**EMAN Zoning Committee  
Variance Request Review:**

**Application Number:** ZP-2021-009509 & ZP-2021-009505

**223 & 225 E Springer St.**

**Proposed**  
**2 Attached Single Family ,**  
**4-story Homes**

Exhibit 1

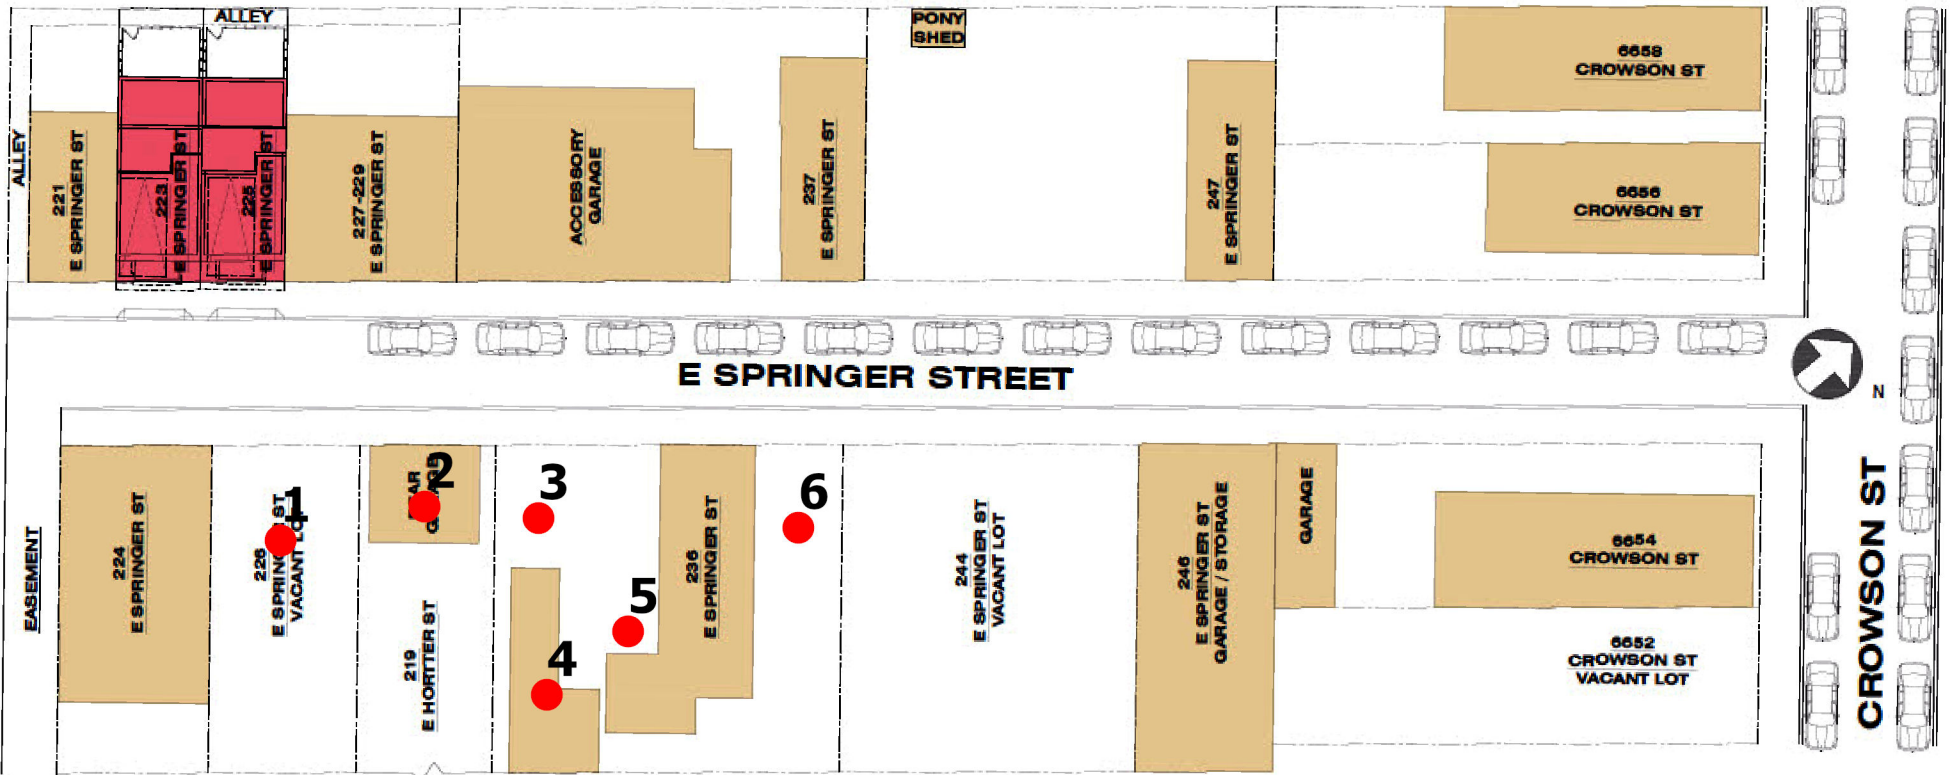
The Committee found several discrepancies between the City’s 2020 aerial drawing and the Applicant’s Site Context Plan:

Discrepancies in SP.00 Context Plan	
Number	Discrepancy
1	226 E Springer St. semi-detached house not shown
2	Garage noted as belonging to 219 Hortter St. is the property of 236 E Springer St. No structures exist on the 219 E Hortter St lot.
3	Buildings in the 236 E Springer property are not property positioned in the Applicant’s Site Context drawing.

The Applicant is asked to correct Drawing SP.00 Context Plan, SP.01 Site Plan, Z.00 and Z.01 to reflect actual building locations along the 200 block of E Springer St and provide a stamped drawing by a registered engineer/ surveyor to confirm that these drawings are dimensionally accurate. The Applicant is asked to update the vehicle turning radii shown in drawings SP.01, Z.00 and Z.01 to ensure that they reflect the actual building locations.
